CRIME IMPACT STATEMENT

Land on Catherine Road

12 No. Apartments

REFERENCE: 2024/0118/CIS/01

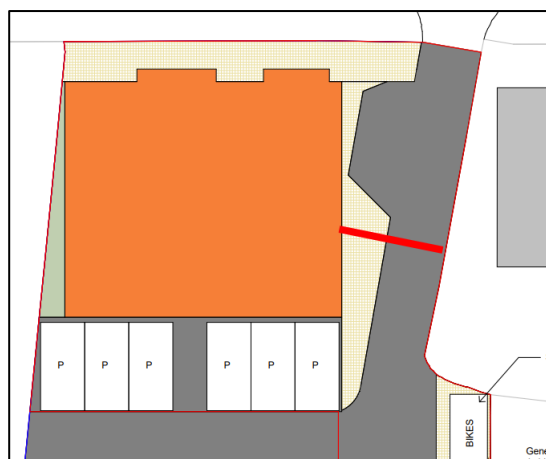
- 3.3.1 The proposed entrance to the building should be brought forward in line with the building elevation to prevent a recess, which can allow an offender to operate without fear of detection.
- 3.3.2 Access to the rear of the apartment building should be restricted to residents to prevent misuse. The car parking area should be secured with access restricted to residents. There should be automated gates, installed at the entrance to the car park as close to flush with the front of the building as possible. The gates should operate on an access control system with access restricted to genuine residents. (See drawing below, red line shows potential position of automated gates).

- 3.3.3 Rear boundary. Security or either development if there is no boundary. (See drawing below, red line shows possible position of rear site boundary).
